UNITED STATES PATENT AND TRADEMARK OFFICE

10/761,830

Office Action Summary

DETAILED ACTION

FIG. 6

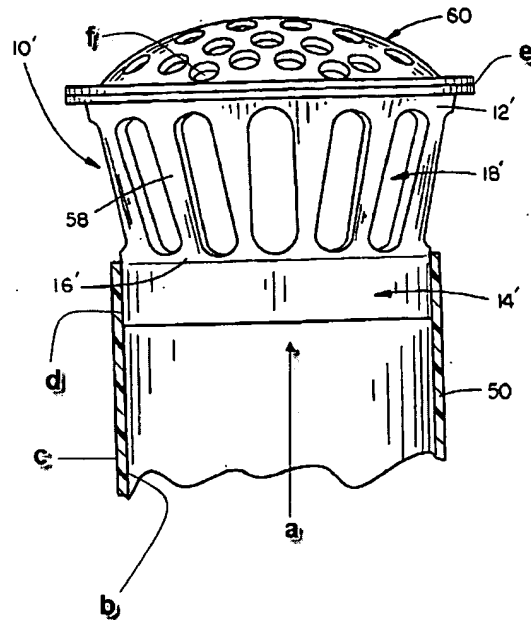
13. Regarding claim 1, Hernandez, in Figure 6, discloses a ventilation pipe protector comprising:

- a. a tubular sleeve (14') having a sleeve outside diameter (d) smaller than a ventilation pipe (50) inside diameter (b), the sleeve (14') comprising an inlet end (a) for receiving a gas.
- b. a hollow head (10') attached to an end of the sleeve opposite the inlet end (16) to allow the gas to flow from the sleeve (14') into the head (10'), the head (10') having a head outside diameter (e) larger than the sleeve outside diameter (d) and comprising a plurality of passageways (f,18') sized to allow egress of the gas from the head and to prevent ingress of animals and debris into the head.

14. Regarding claim 2, Hernandez, in Figure 6, discloses a ventilation pipe protector comprising a head (10') with a convex shaped end (60) opposite an end of the head attached to the sleeve (16').

15. Regarding claim 4, Hernandez, in Figure 6, discloses a ventilation pipe protector comprising a head outside diameter (e) that is larger than a ventilation pipe (50) outside diameter (c).

16. Regarding claim 7, Hernandez, in Figure 6, discloses a ventilation pipe protector comprising:

- a. a tubular sleeve (14') having a sleeve outside periphery (d) smaller than a ventilation pipe (50) inside periphery (b), the sleeve (14') comprising an inlet end (a) for receiving a gas.
- b. a hollow head (10') attached to an end of the sleeve opposite the inlet end (16) to allow the gas to flow from the sleeve (14') into the head (10'), the head (10') having a head outside periphery (e) larger than the sleeve outside periphery (d) and comprising a plurality of passageways (f, 18') sized to allow egress of the gas from the head and to prevent ingress of animals and debris into the head.

Levy (U.S. Patent No. 926,704)

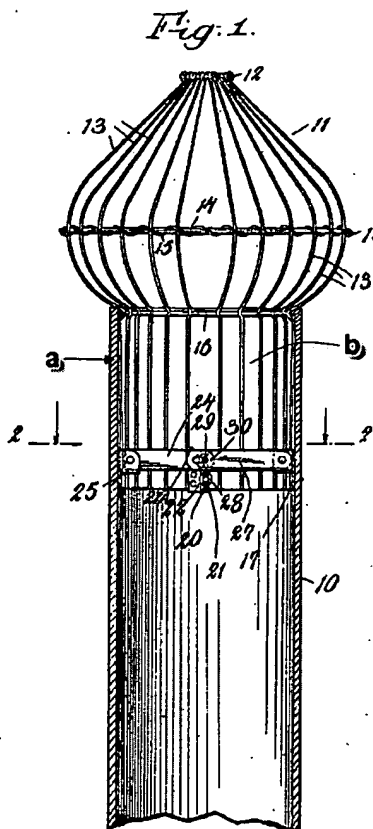
19. Claims 5 is rejected under 35 U.S.C. 103(a) as being unpatentable over Hernandez ('554 A1) in view of Levy (U.S. Patent No. 926,704). Hernandez discloses the limitations as discussed above, but does not disclose the sleeve comprising a plurality of passageways sized to allow the gas to flow from the ventilation pipe into the sleeve. However, Levy in Figure 1, teaches a vent strainer with a sleeve (a) comprising a plurality of passageways (b) sized to allow the gas to flow from the ventilation pipe into the sleeve. Therefore, it would have been obvious to a person having ordinary skill in the arts at the time of the applicant's invention to modify the ventilation pipe protector of Hernandez to include a sleeve comprising a plurality of passageways sized to allow the gas to flow from the ventilation pipe into the sleeve as taught by Levy to provide a sleeve that can be readily attached onto the ventilation pipe (Page 1, Ln 9-16).

FIG. 9

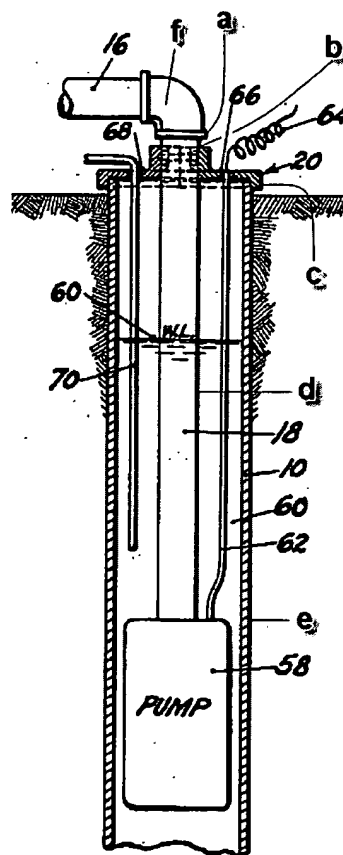
20. Claims 6 is rejected under 35 U.S.C. 103(a) as being unpatentable over Hernandez ('554 A1) in view of Brenner (U.S. Patent No. 2,768,007). Hernandez discloses the limitations as discussed above, but does not disclose a washer disposed around the sleeve and abutting the head, the washer comprising a washer inside diameter larger than the sleeve outside diameter and smaller than the head outside diameter, and an outside diameter larger than the ventilation pipe outside diameter. However, Benner in Figure 9, teaches a washer (20) disposed around the sleeve (18) and abutting a head (f), the washer (20) comprising a washer inside diameter (b) larger

than the sleeve outside diameter (d) and smaller than the head outside diameter (a), and an outside diameter (c) larger than the pipe (10) outside diameter (e). Therefore, it would have been obvious to a person having ordinary skill in the arts at the time of the applicant's invention to modify the ventilation pipe protector of Hernandez to include a washer disposed around the sleeve and abutting the head, the washer comprising a washer inside diameter larger than the sleeve outside diameter and smaller than the head outside diameter, and an outside diameter larger than the ventilation pipe outside diameter as taught by Benner to allow any diameter sleeve and head to fit into a pipe with a larger diameter without falling through (Col 2, Ln 30-37).
